Dublin Cycling Campaign
% Tailor's Hall,
Back Lane,
Dublin 8
5 April 2021

Dublin Cycling Campaign Submission on Lower Dodder Road

DODDER ROAD LOWER PART 8 SECTION 1-1 COMPARISON

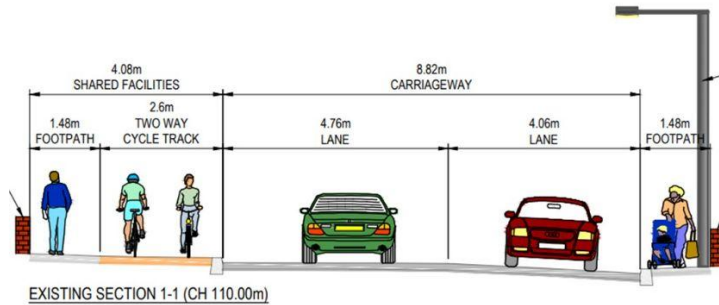
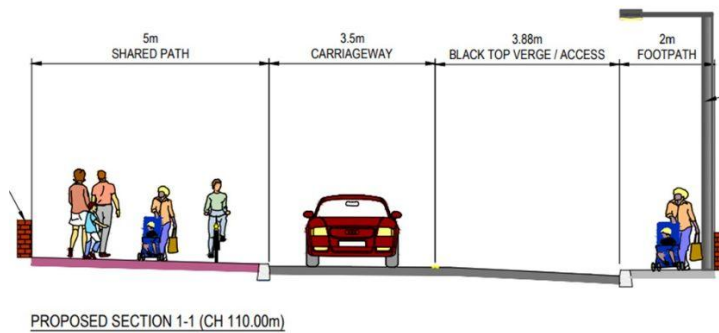
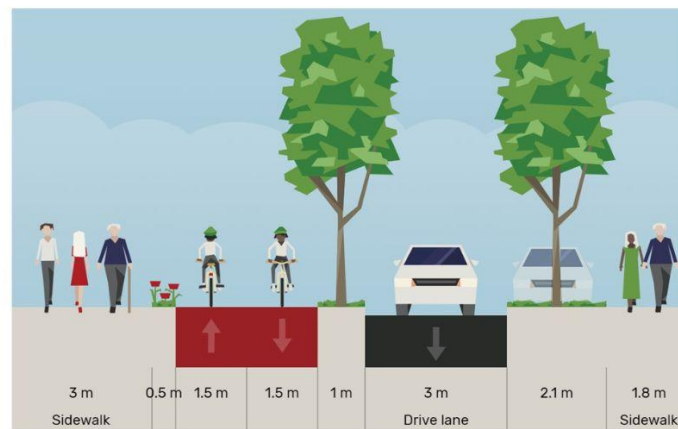
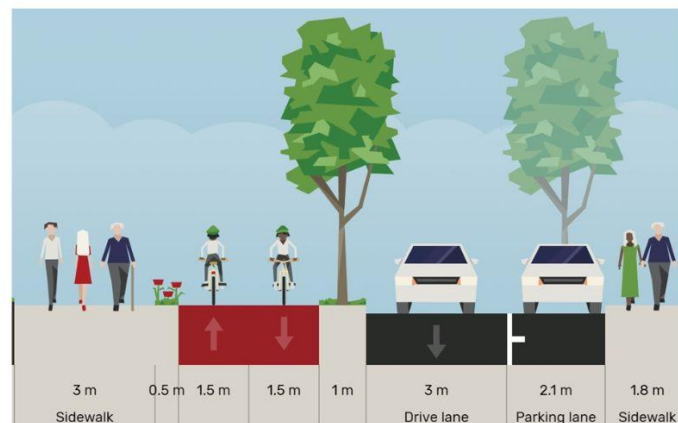
If the carriageway width is reduced to 3m there is enough space to provide a green vegetation strip between the footpath, cycle track and road. Note that this is wider than the width recommended by DMURS (section 4.4.1) which says “The standard carriageway width on Local streets should be between 5-5.5m (i.e. with lane widths of 2.5-2.75m)”.

Another concern is that the shared path will be used for short-term parking for drop offs and deliveries along the whole route. So it should be protected with a narrow, low height vegetated verge along its length where possible.

Alternative Section 1-1 A

Alternative Section 1-1 B
